## Observations and Scrutiny of Material considerations

S22-0538 Planning Application by Agri-Linc Holdings Ltd

Concessions By Applicant

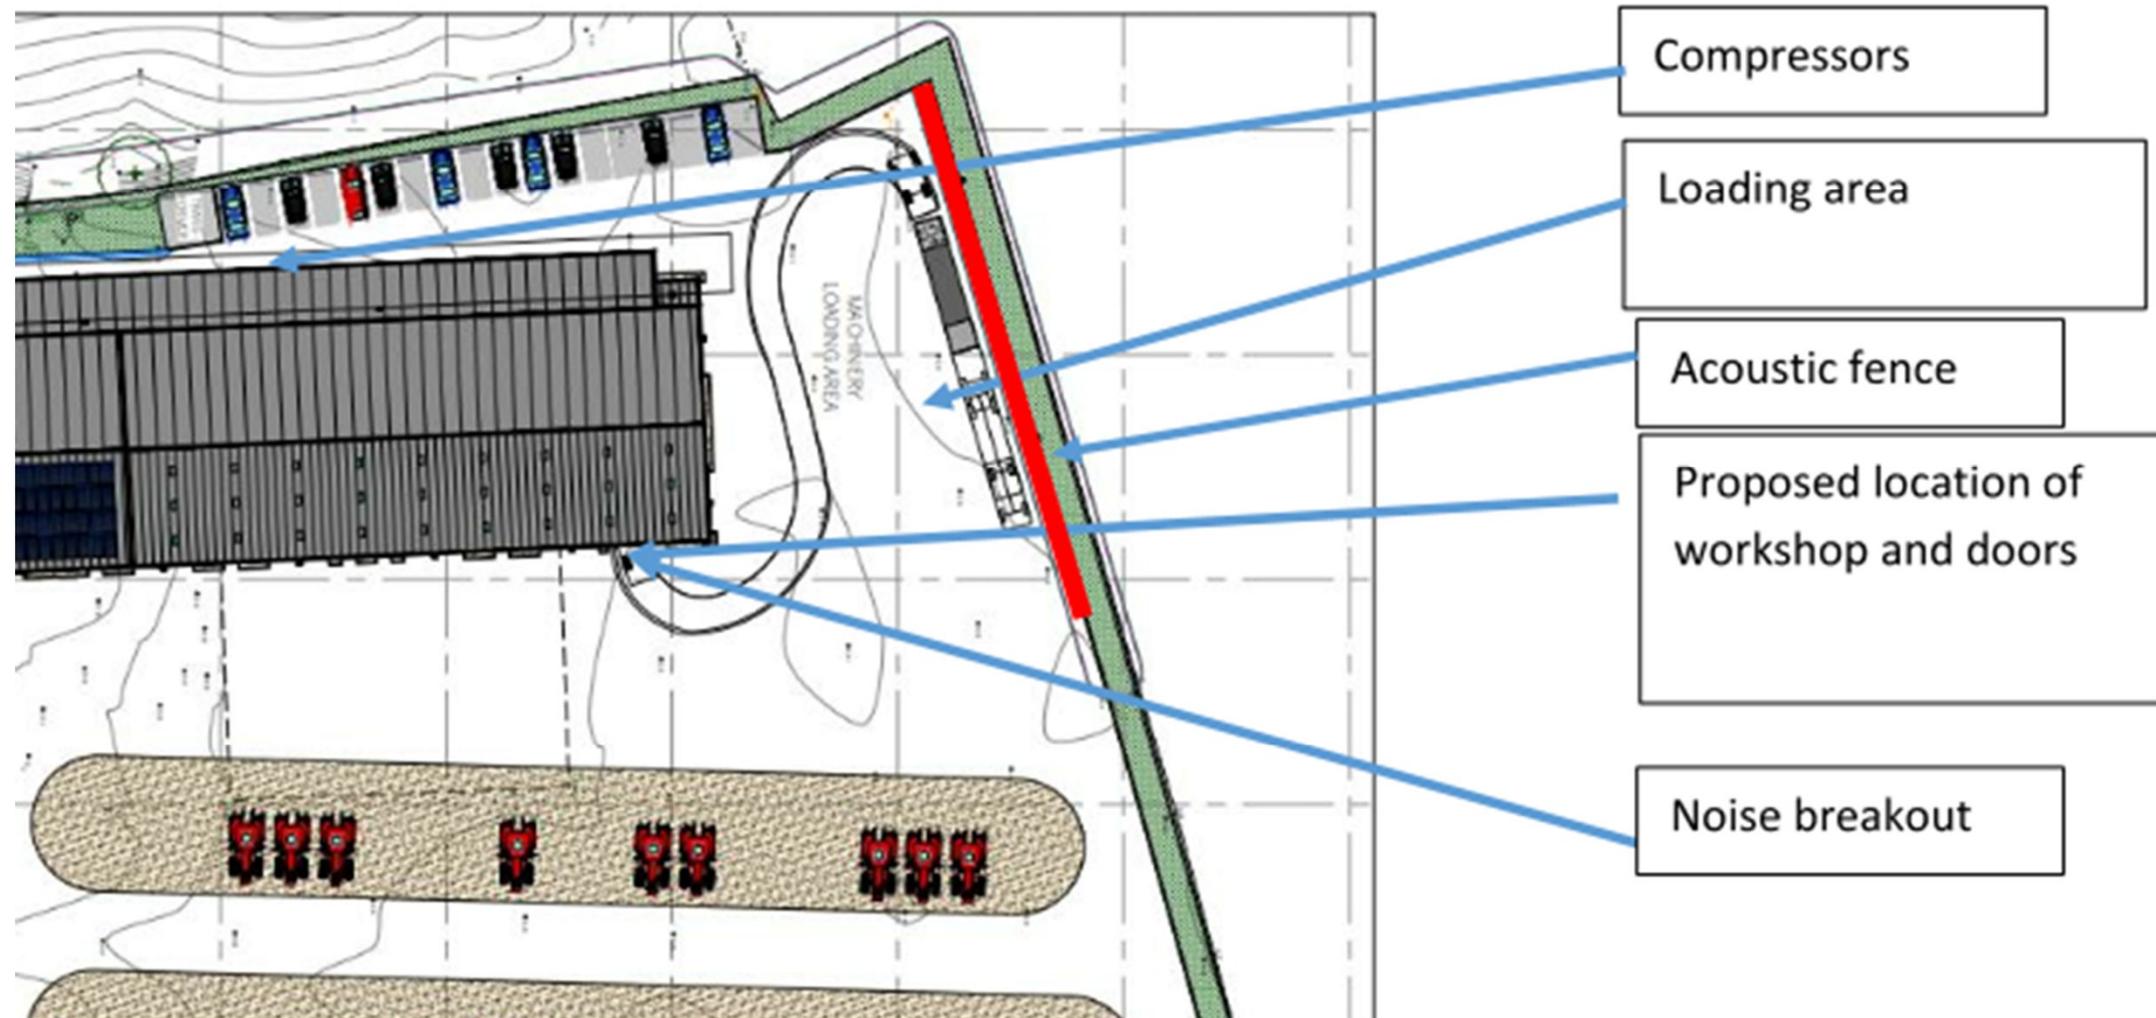
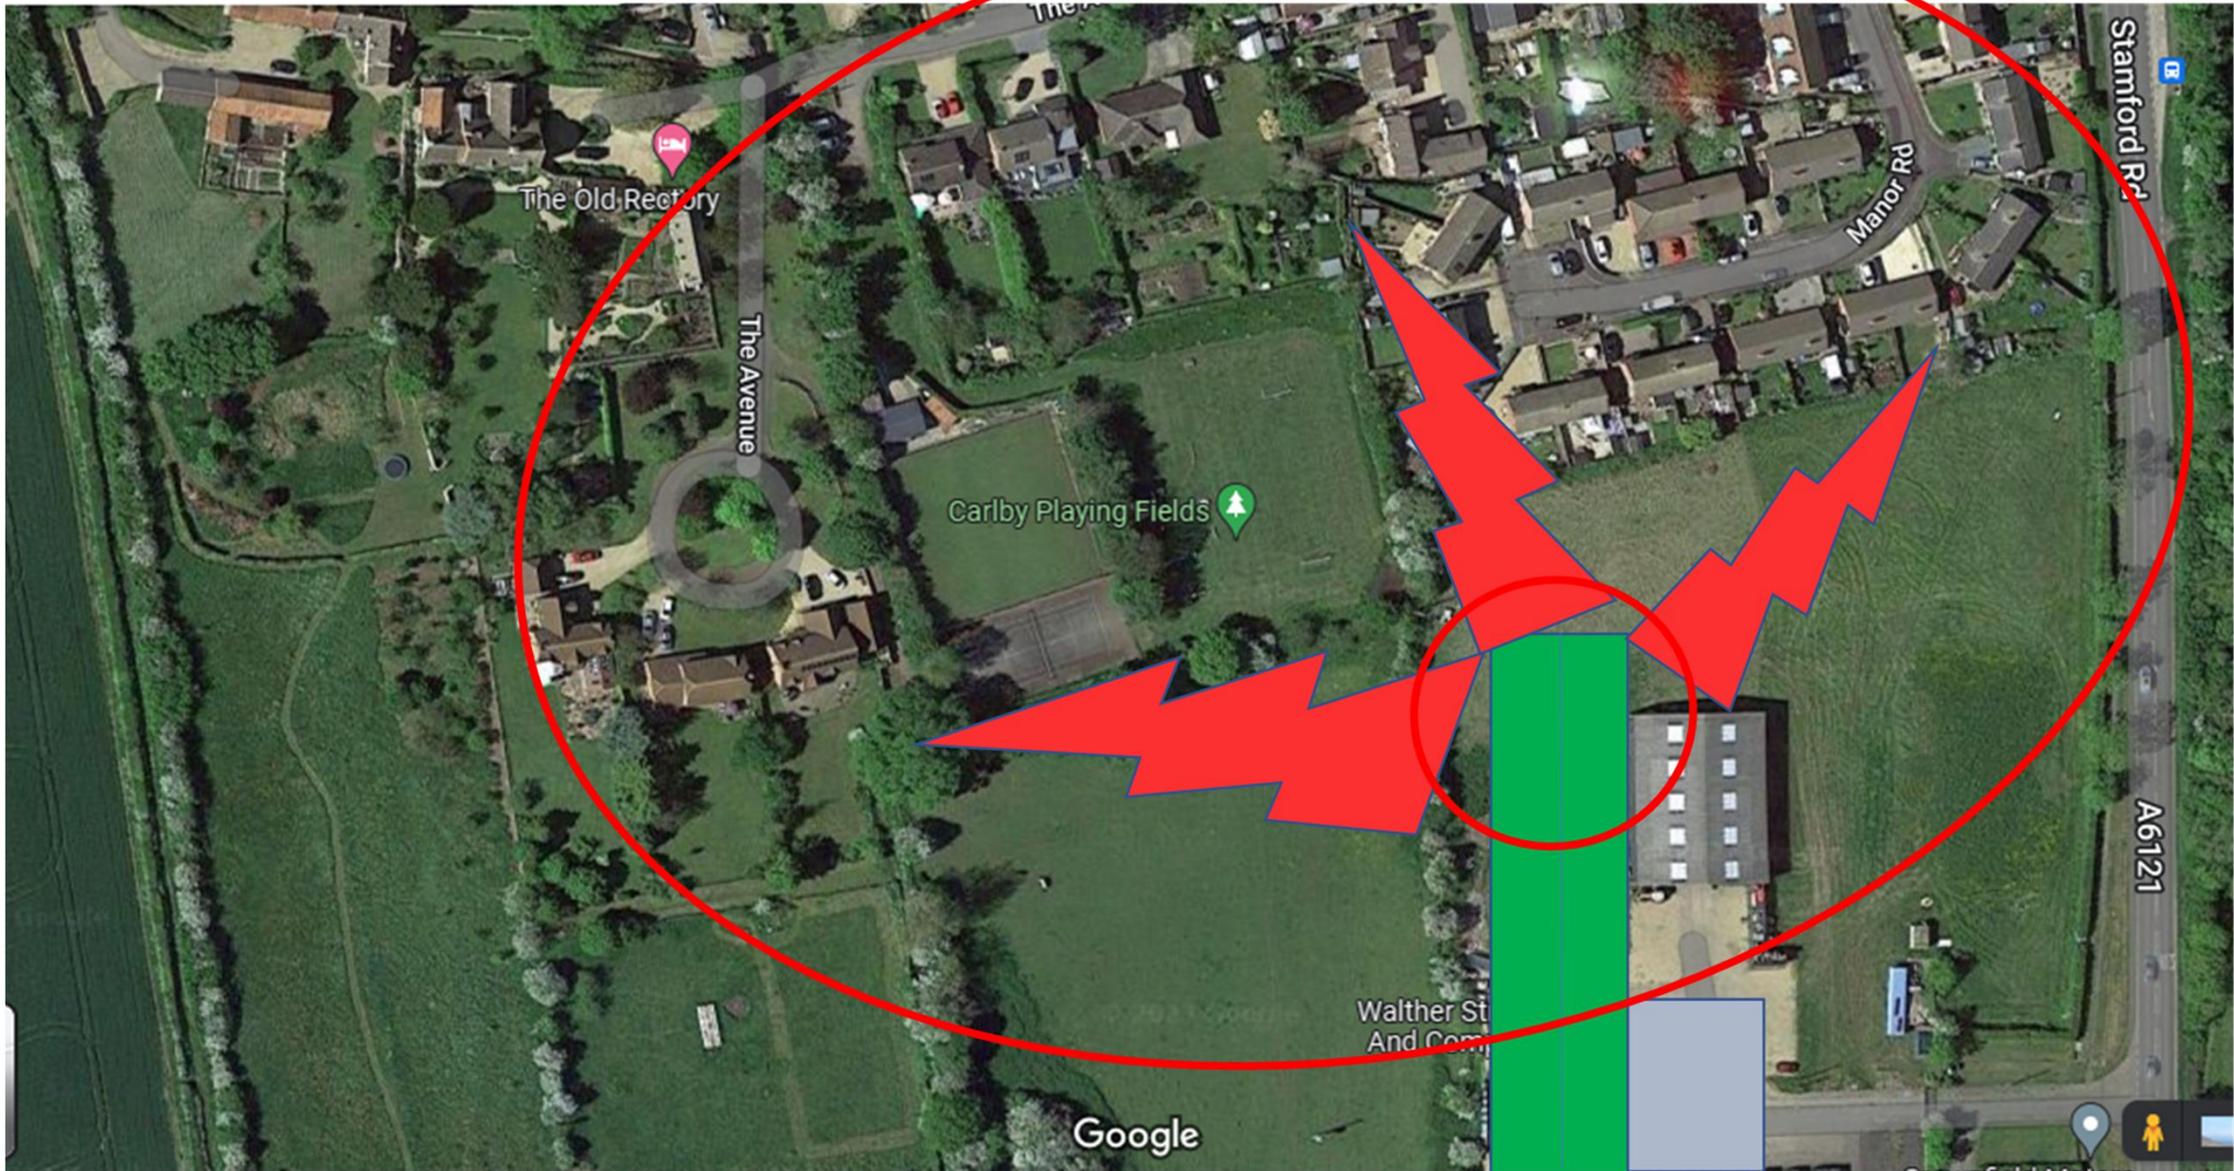
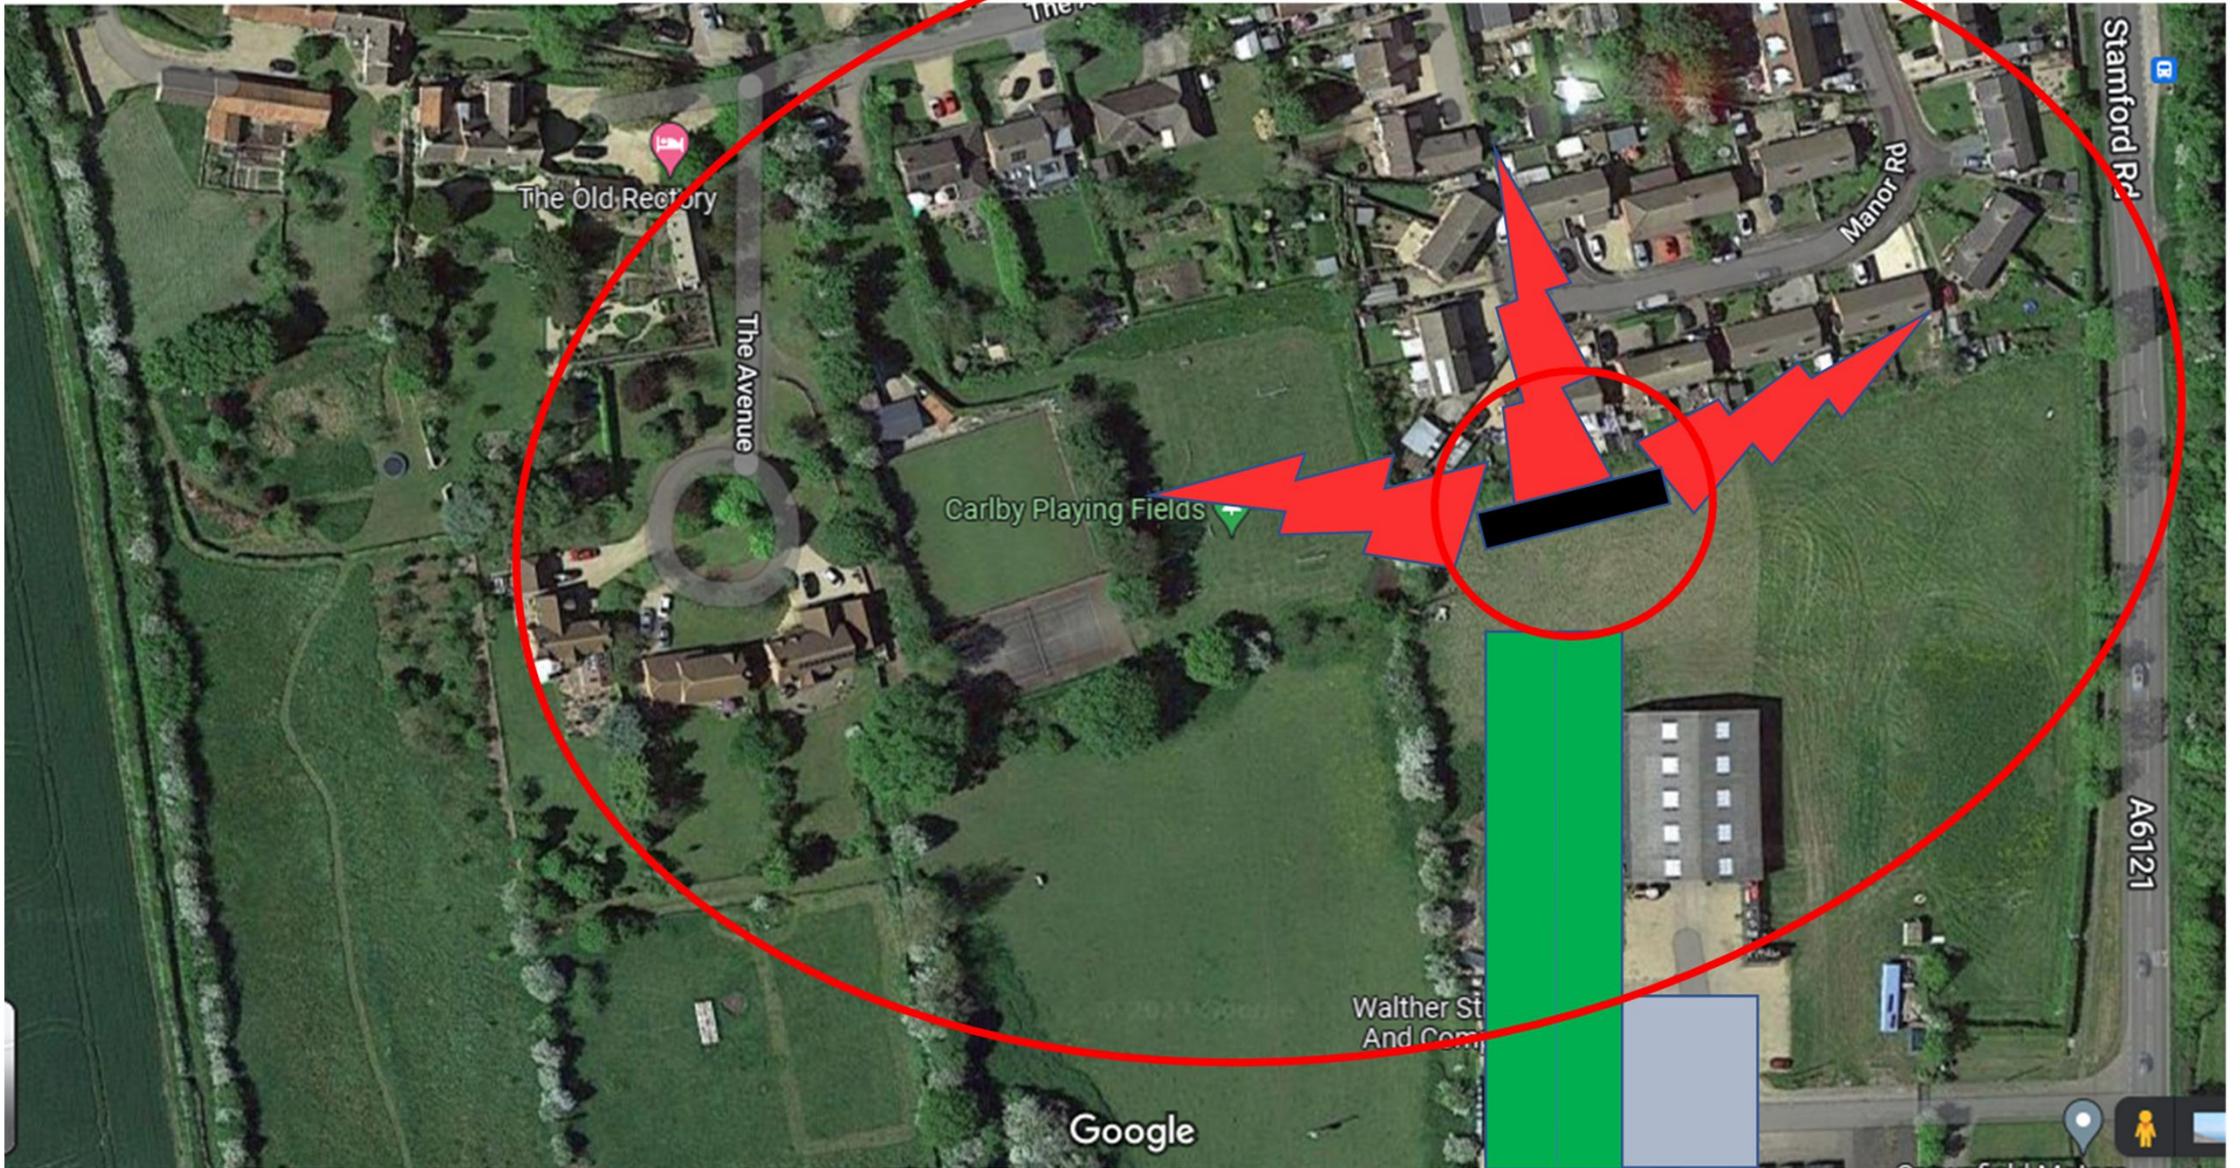
If all the doors are kept close during operations, then noise should not drift as far as the red circle of potential pollution.

The loading ramp and loading area are the root cause of noise from HGVs and Fork Lift Trucks

Add acoustic fence as mitigation to attenuate noise from the loading ramp and area

## Noise mitigation

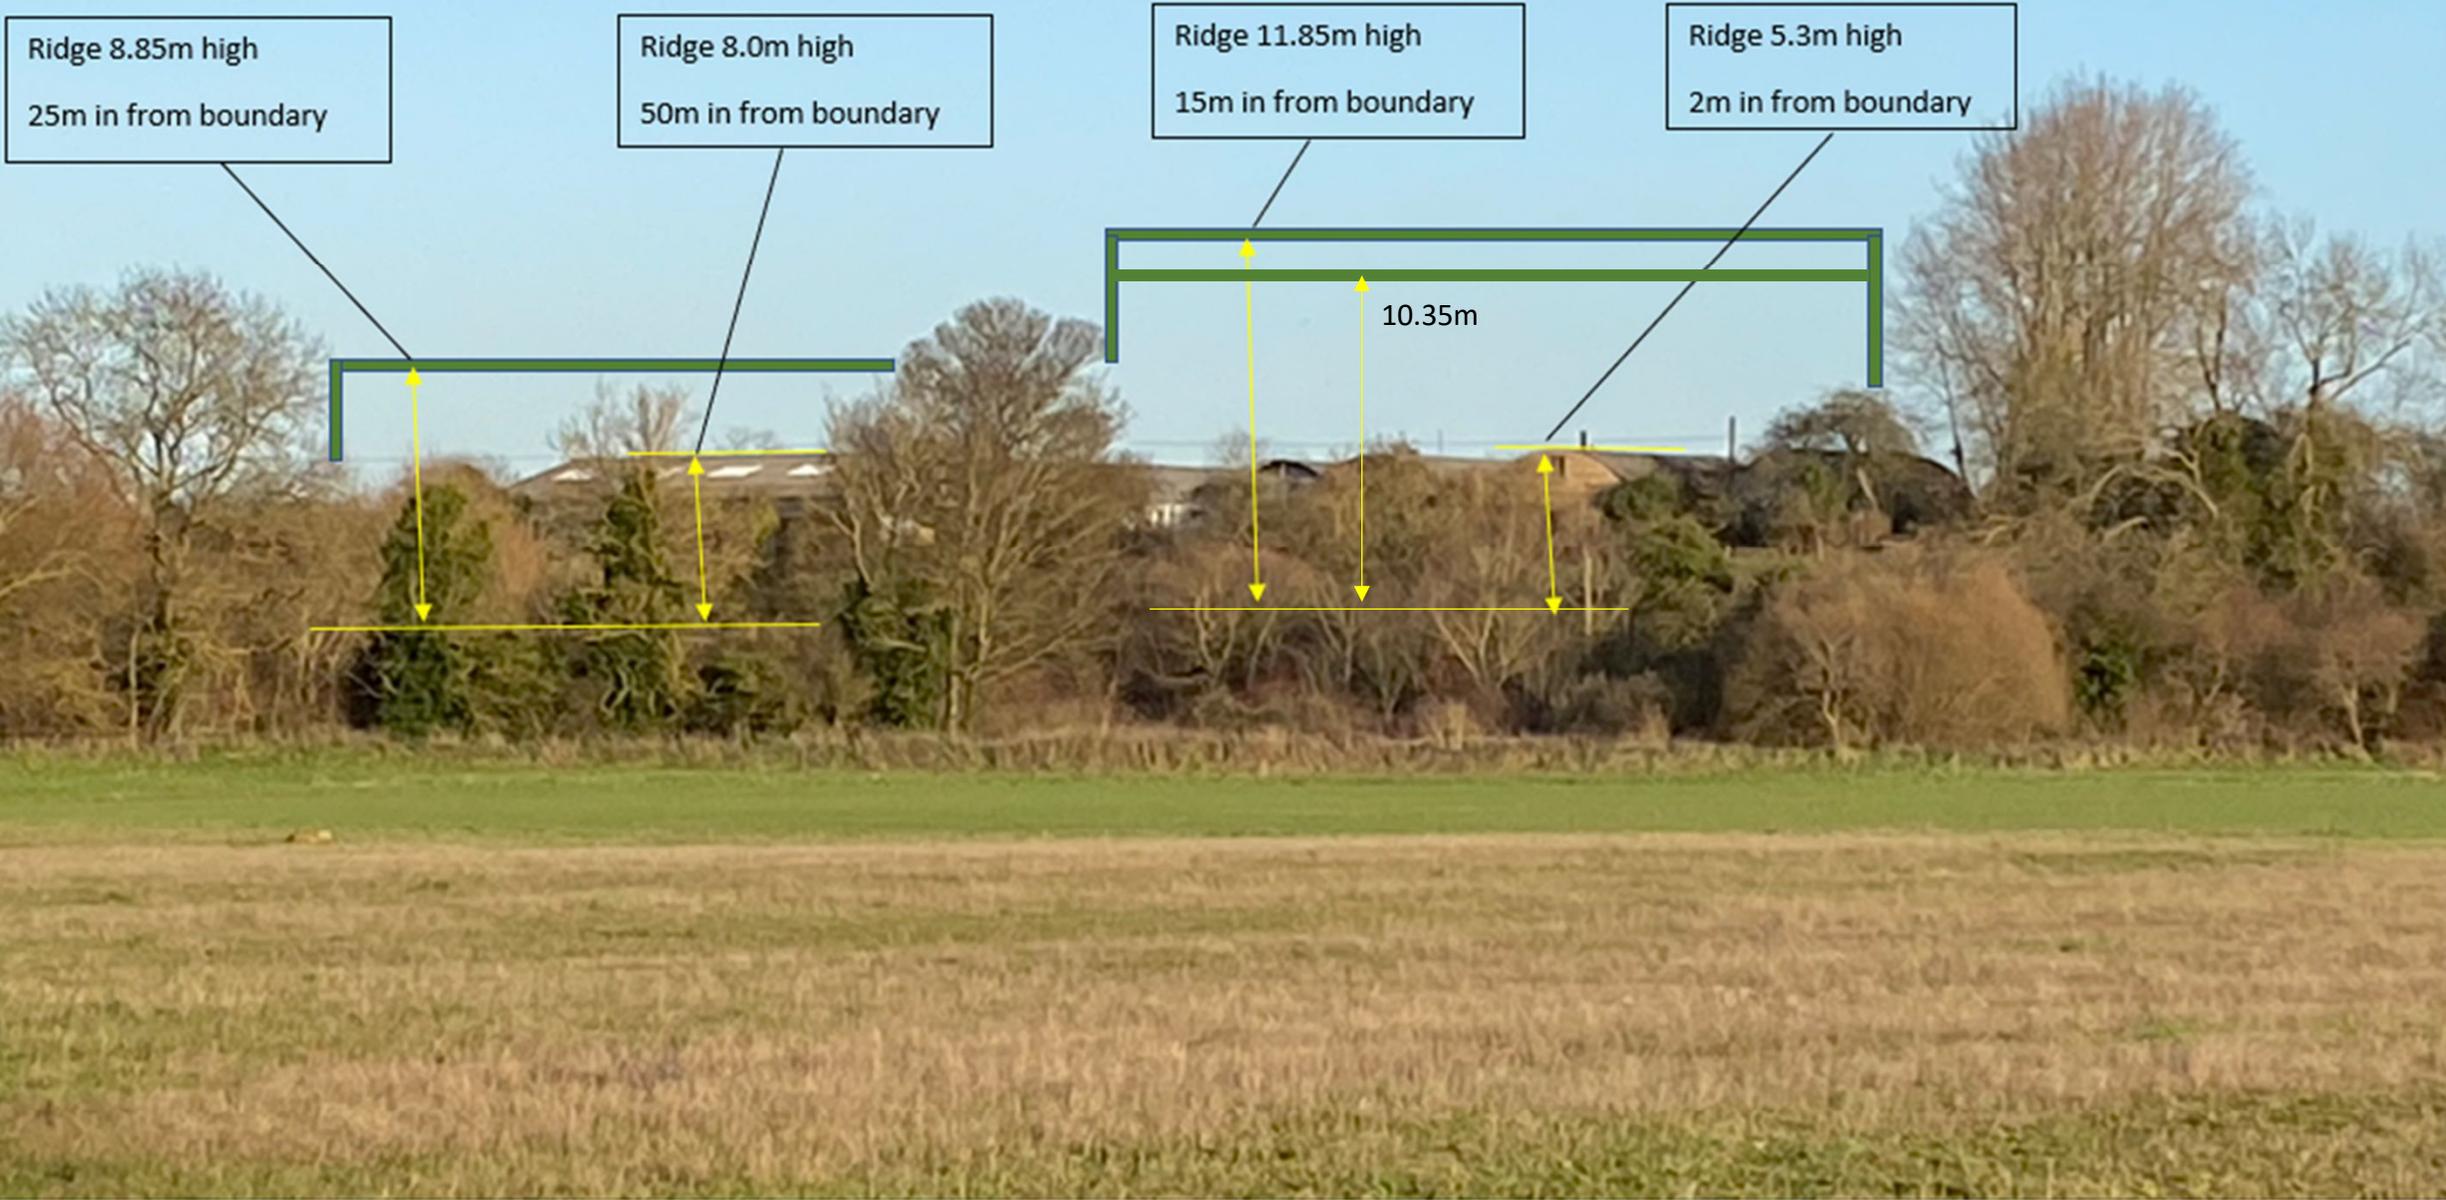
All measures should be imposed and actively carried out

At all times apart from ingress and egress keep the doors shut

- a) Appropriate acoustic fence (3-4m high) along the boundary of the machinery loading area (see Appendix A) to remove the line of sight and maintain the low noise level to the adjacent NSRs.
